Addendum Number Two

**Rock Creek USD 323
ST. GEORGE ELEMENTARY SCHOOL
Humidity Control Bid Package**

Issued: Thursday, October 20, 2022

1.8 Sheet 10 of 21

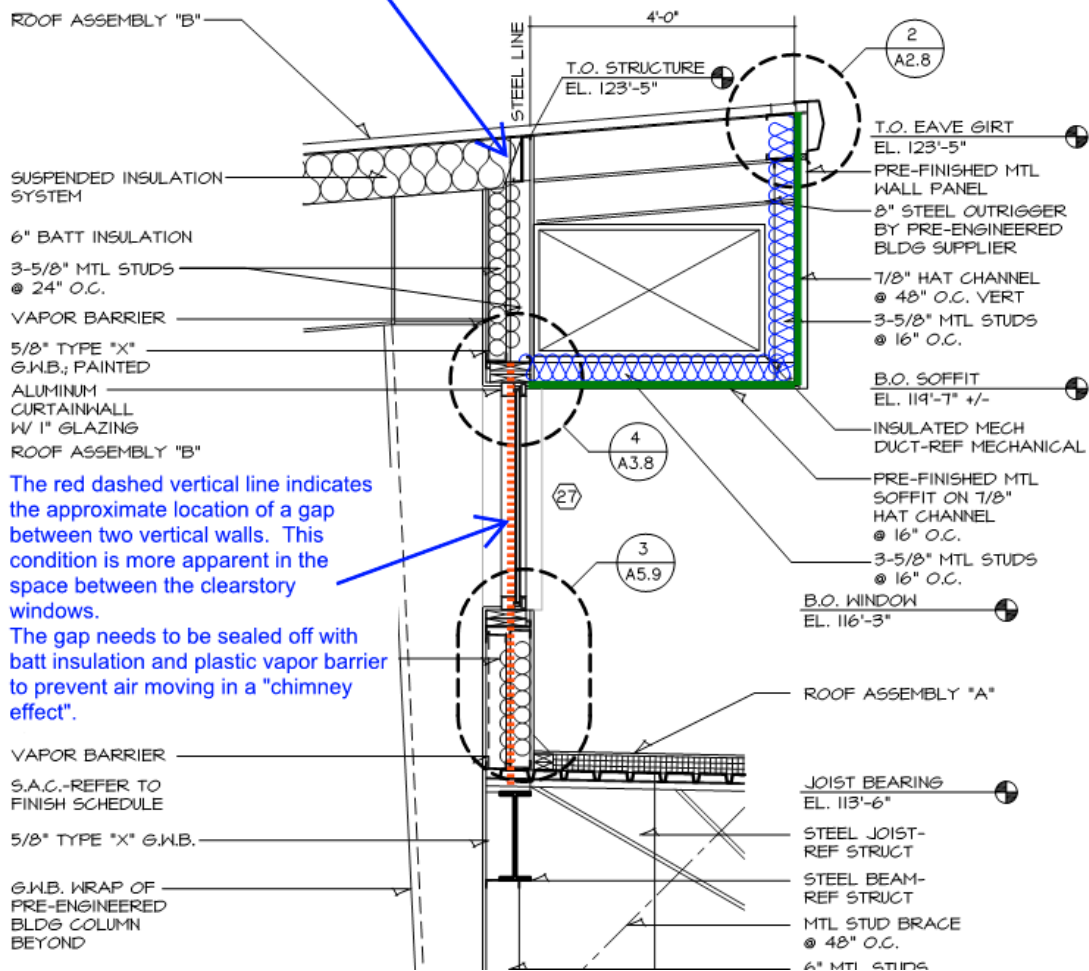
- a. The existing roof insulation does not appear to cover the roof portion over the duct. This most likely reflects the as built condition (as shown on the detail).
- b. The notes below are to supplement those shown on Sheet 10 of 21.

Once the soffit is open, the GC and Architect shall review the conditions of the back vertical wall and the soffit ends.
